2017:30

SSM's external experts' review of
SKB's safety assessment SR-PSU
– consequence analysis
Main review phase

SSM's external experts' review of
SKB's safety assessment SR-PSU
– consequence analysis

SR-PSU Main Review Phase: Radionuclide Transport Modelling

Figure 2. Configuration of compartments used to represent waste packages in ECOLEGO

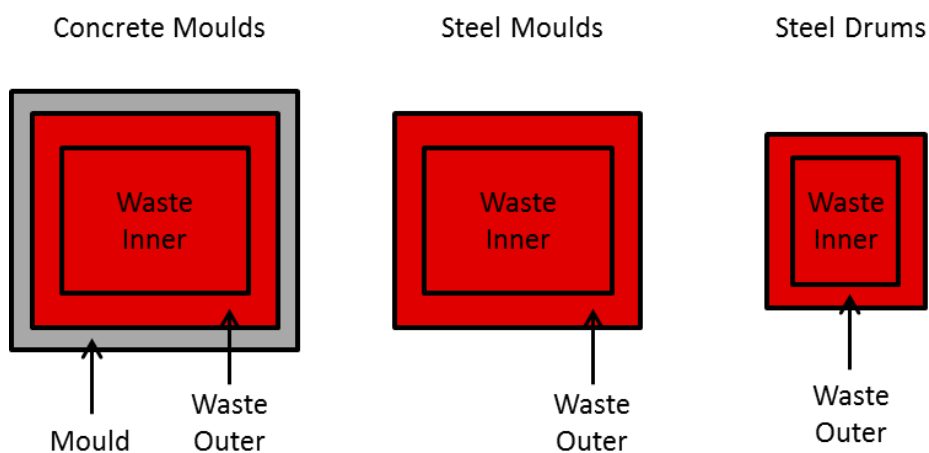
During inspection of the ECOLEGO model files, it was identified that the configuration of the compartments used to represent the waste packages had been misunderstood from the description given in Section 9.3.1 of TR-14-09. In the ECOLEGO model, each package type is represented by two compartments: an inner waste compartment and an outer waste compartment. The concrete moulds associated with cement solidified waste and cement embedded wastes are represented separately. This is illustrated in Figure 2. Therefore, for each of the 14 caissons there are the following additional waste package compartments compared with the AMBER model:

Therefore there are an additional $6 \times 14 = 84$ waste package compartments compared with the AMBER model. It was decided not to include these additional compartments in the AMBER model, but instead test sensitivity of the calculated fluxes to the discretisation of the waste packages for one caisson as a variant calculation.

Figure 14. Distributions of geosphere travel time (Figure A-2 in TR-14-09)

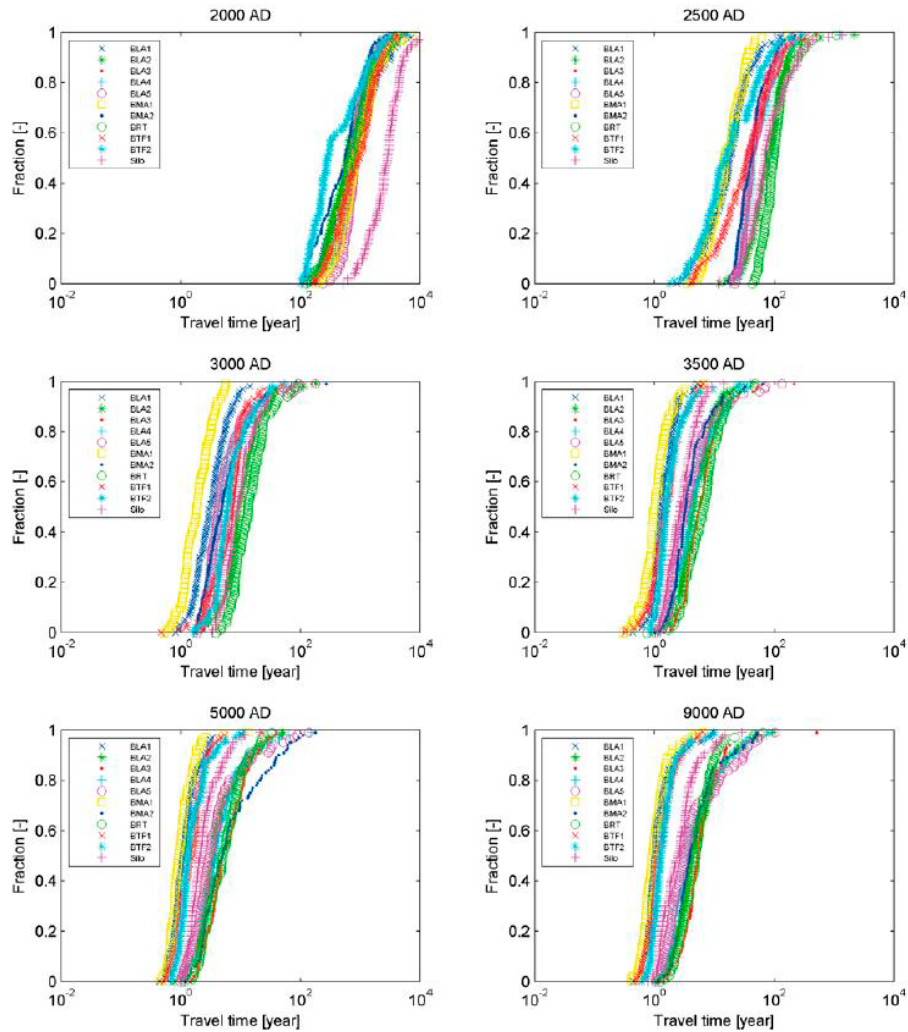
A-2 (Figure 14) and A-3 in TR-14-09 show the distributions of the travel times and flow wetted surface areas for the different vaults and the silo at different times. The values used in the Global Warming Calculation Case were taken from the ECOLEGO model files. These are reported in Table 15. Dispersion was not modelled explicitly in the AMBER model, but instead was represented implicitly by using a discretisation that results in an amount of numerical dispersion that may be comparable to the amount of dispersion that would be expected in reality. We could not find the Peclet number used by SKB in their reports.

Figure 18. Comparison of radionuclide fluxes from the near-field into the rock calculated by the AMBER (AMB) and ECOLEGO (ECL) models

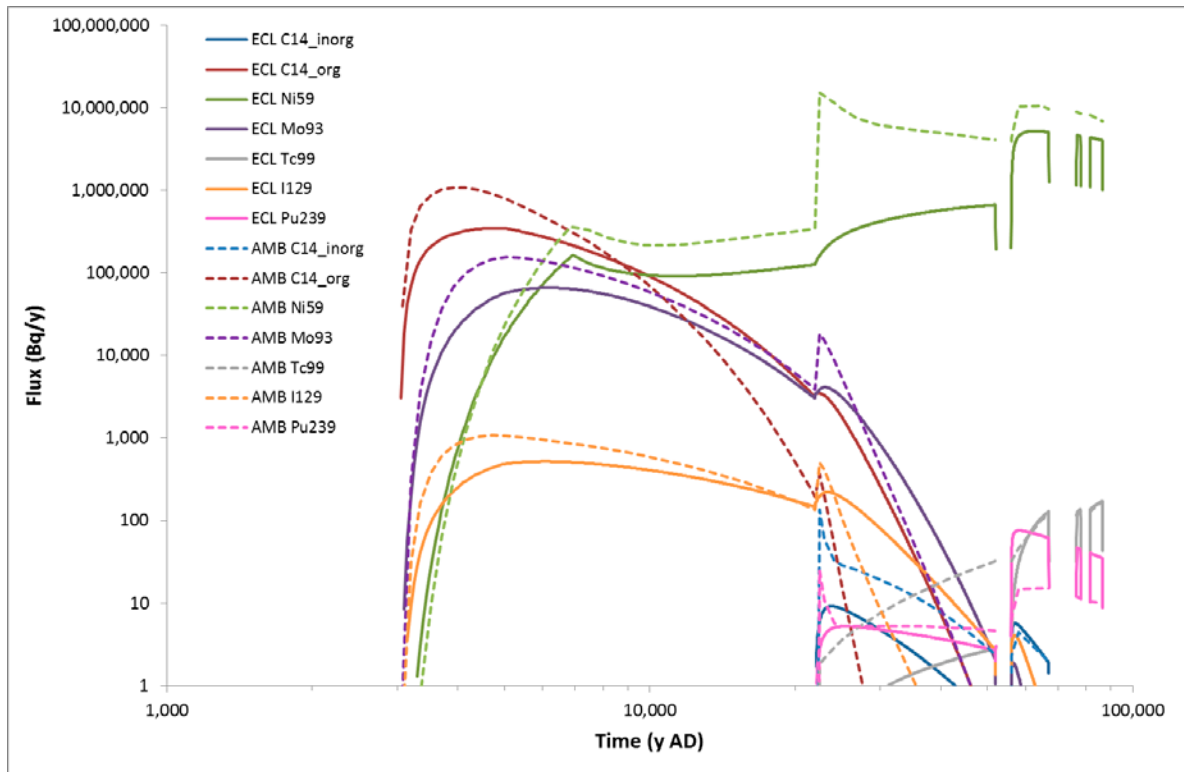
Figure 18 compares the fluxes from the near-field to the geosphere calculated by the ECOLEGO and AMBER models. Results for radionuclides with the highest fluxes are compared. C-14_{org} is not sorbed, while I-129 and Mo-93 are only weakly sorbed. These three radionuclides exhibit similar behaviour, and the AMBER model results are similar to the ECOLEGO model. However, in all cases the radionuclide release is initially faster in the AMBER model, and the peak flux is higher. The fluxes then decrease more rapidly in the AMBER model because more of the inventory has been released at early times.

Figure 1. Comparison of radionuclides fluxes from the 2BMA vault to the geosphere calculated by AMBER (AMB) for the CCM_GW, compared with the original SR-PSU ECOLEGO (ECO) results (top) and the new corrected ECOLEGO (ECL) results (bottom)

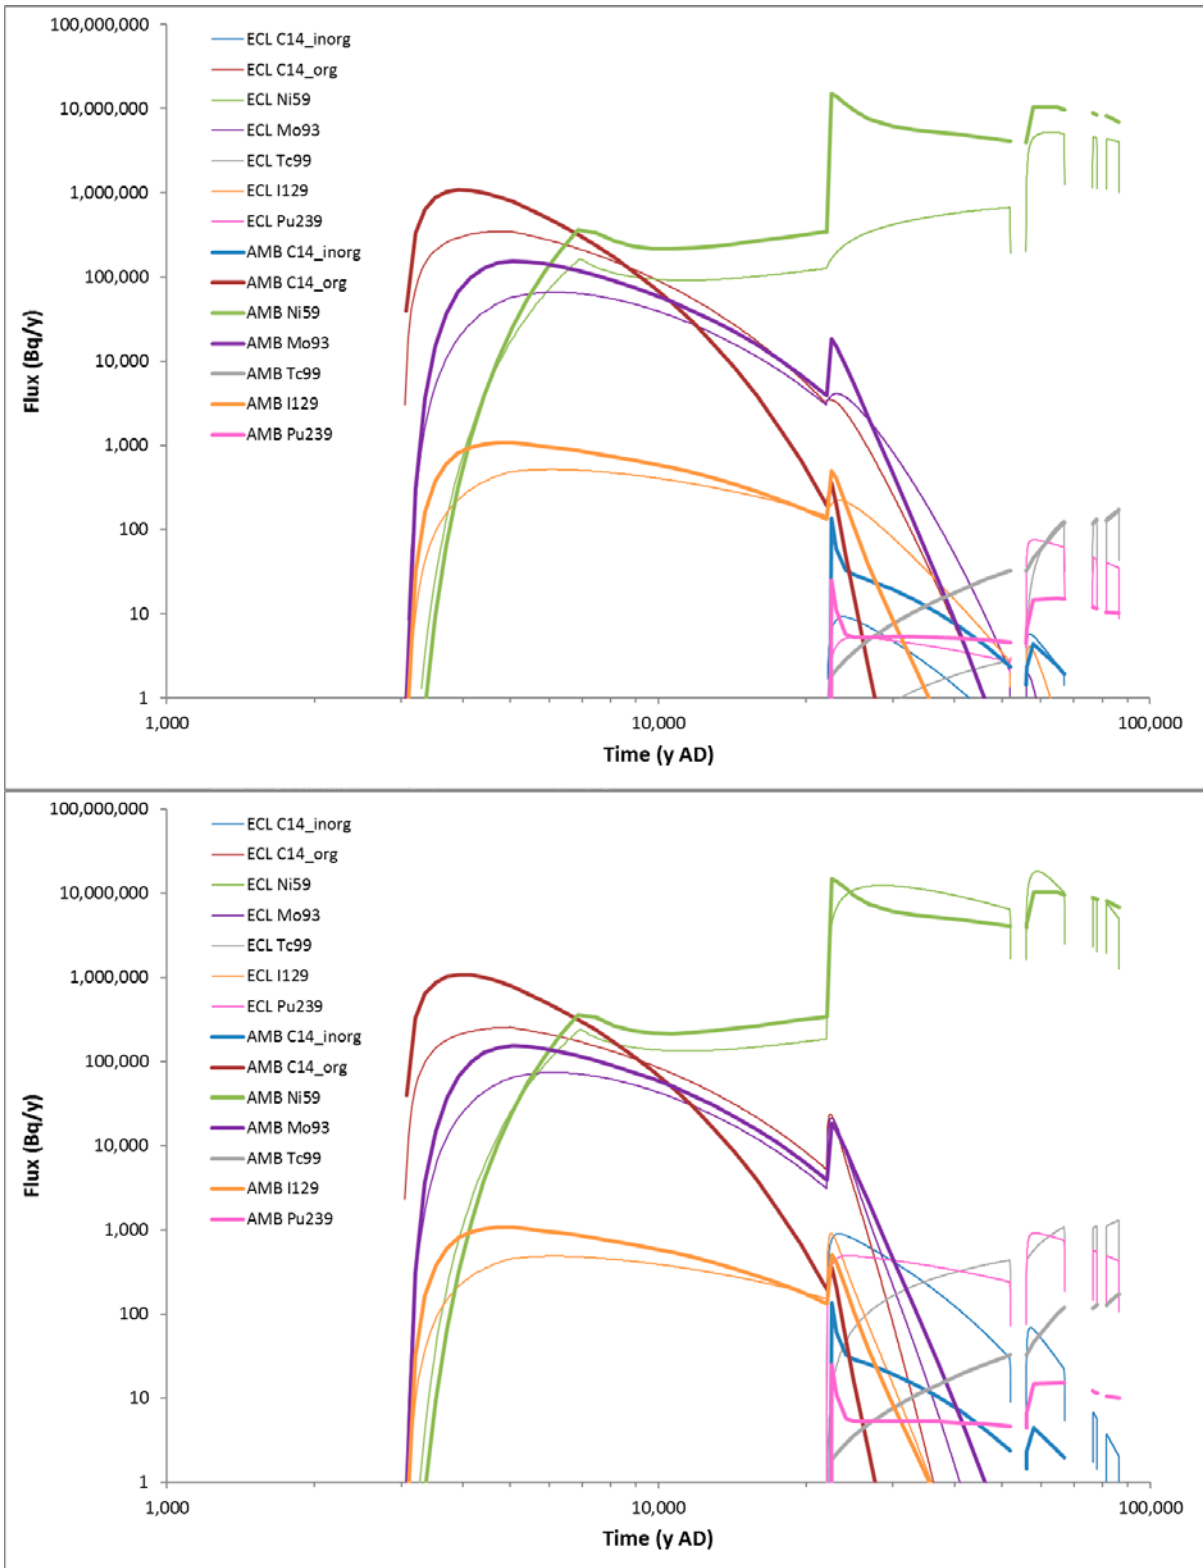
Selected radionuclides fluxes from the near-field to the geosphere calculated by AMBER for the CCM_GW are compared with the original SR-PSU results (top) and the new corrected results from SKB (2017) (bottom) in Figure 1. The potential reasons for the differences between the AMBER results and SR-PSU results have been explored by Towler and Penfold (2017) and are not repeated here. Of note is the significant difference in the fluxes at 22,000 AD when the caissons are assumed to fracture. The fluxes calculated by AMBER exhibit a step increase at this time. The original SR-PSU results exhibit a smaller and more gradual increase. The corrected results exhibit a larger step increase in the fluxes, that is much more consistent with the AMBER results.

Figure 2. Corrected (top) and original (bottom) calculated doses from radionuclides released from the 2BMA vault for the CCM_GW calculation case (SKB, 2017)

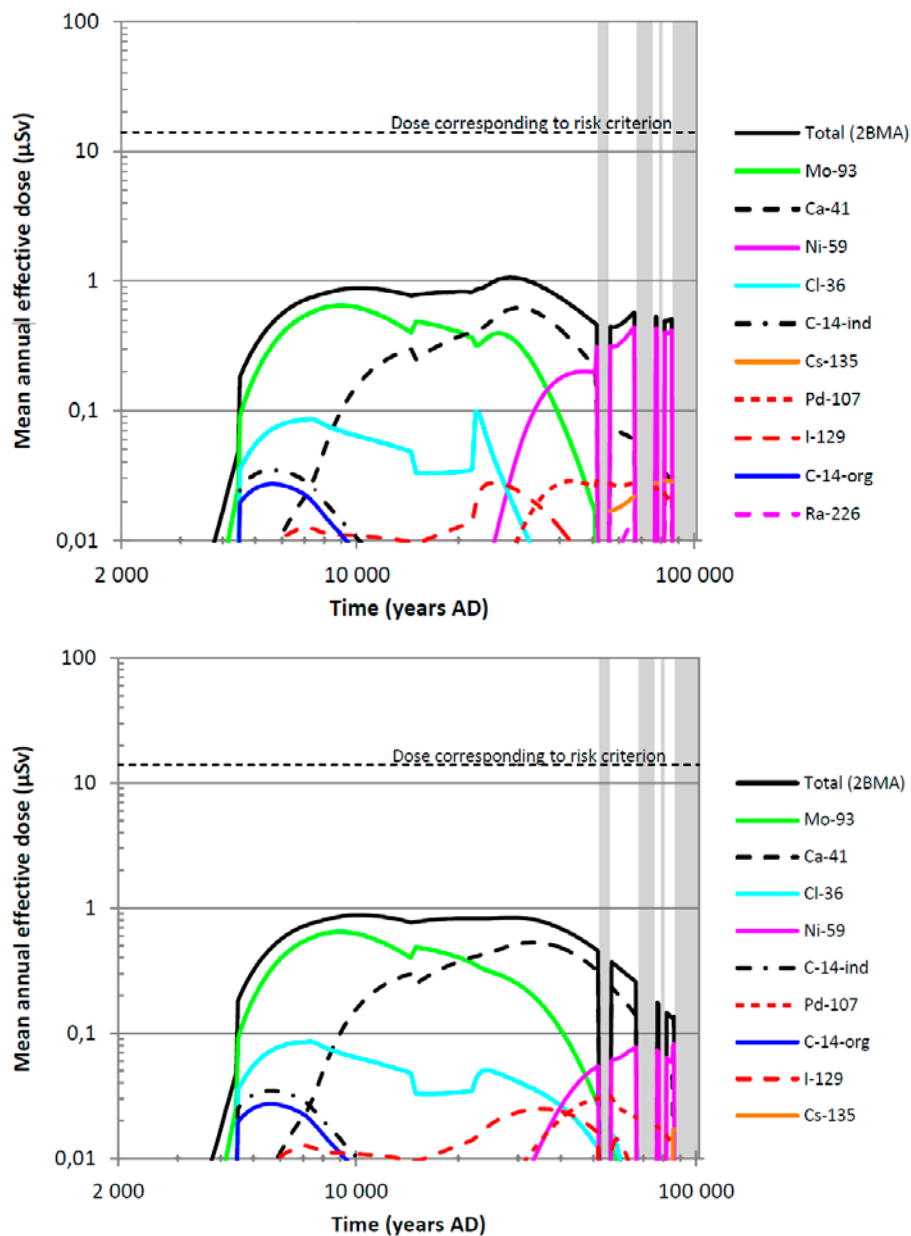
The calculated doses for the original and corrected CCM_GW cases are compared in Figure 2. Cl-36 and I-129 are not sorbed in the geosphere. In the corrected model there is a significant increase in the doses just after 22,000 AD, i.e. shortly after cracking of the caissons, when the fracture flow model is invoked for transport through the caissons. Cl and I are not sorbed in the geosphere (Table 8-6 in TR-14-10), hence a step increase in the releases from the caissons results in a step increase in biosphere doses only a short time later.

Mo is not sorbed in the geosphere either, and Figure 19 in Towler and Penfold (2017) shows that the Mo-93 fluxes from the geosphere to the biosphere calculated by AMBER exhibit a step increase at 22,000 AD. However, the doses due to Mo-93 decrease at 22,000 AD. The different responses of the calculated doses must be due to different behaviour of Mo compared with Cl and I in the biosphere.

Figure 6. Comparison of radionuclide fluxes from the 2BMA vault to the geosphere calculated by AMBER (AMB) and the corrected fluxes calculated by ECOLEGO (ECL) for the accelerated concrete degradation calculation case

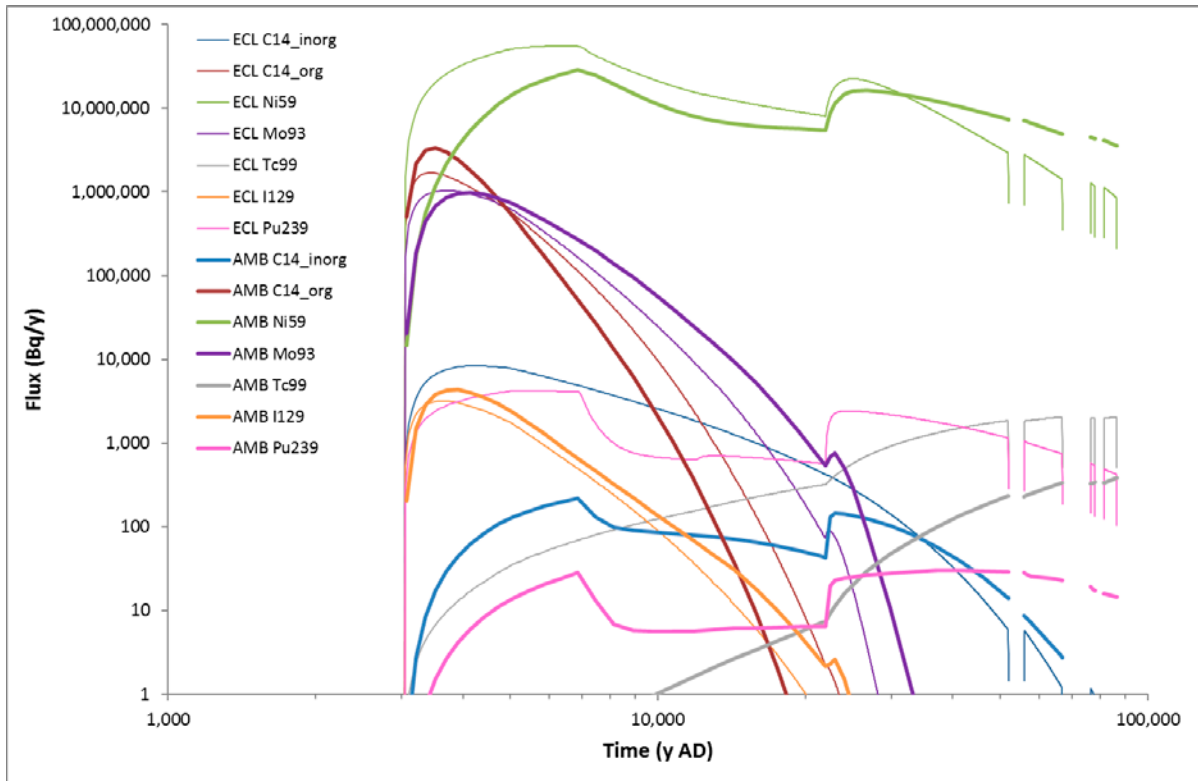
The fluxes from the near-field to the geosphere calculated by AMBER and ECOLEGO are similar for C-14_{org}, Ni-59, Mo-93 and I-129 (Figure 6). However, the fluxes calculated by ECOLEGO are significantly greater than calculated by AMBER for radionuclides that are more strongly sorbed, i.e. C-14_{inorg}, Tc-99 and Pu-239. The ECOLEGO model results will therefore lead to higher calculated biosphere doses than the AMBER model results for these more strongly sorbed radionuclides. However, the calculated biosphere doses are dominated by radionuclides that are not sorbed, or are only weakly sorbed. These more strongly sorbed radionuclides are of secondary importance. The reasons for these differences are further explored in Section 4.

Figure 10. Representation of the waste packages in a caisson, in 2BMA, in ECOLEGO.

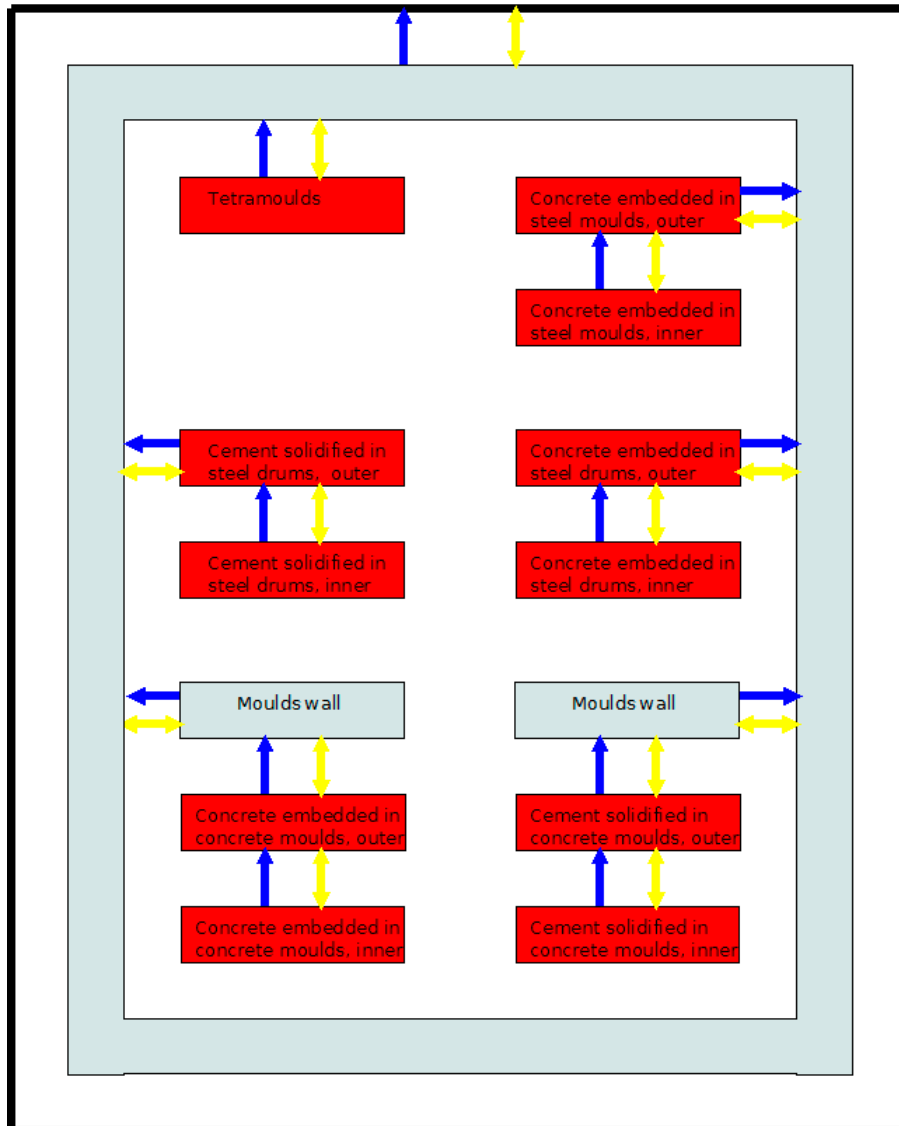
resins), but this waste package type is not present in Figure 10, so it is not clear how they are represented in ECOLEGO.

Cement solidified wastes in steel drums are included in Figure 10, but there are no wastes of this type given in Appendix A of TR-14-02. Therefore they were not included in the AMBER model.
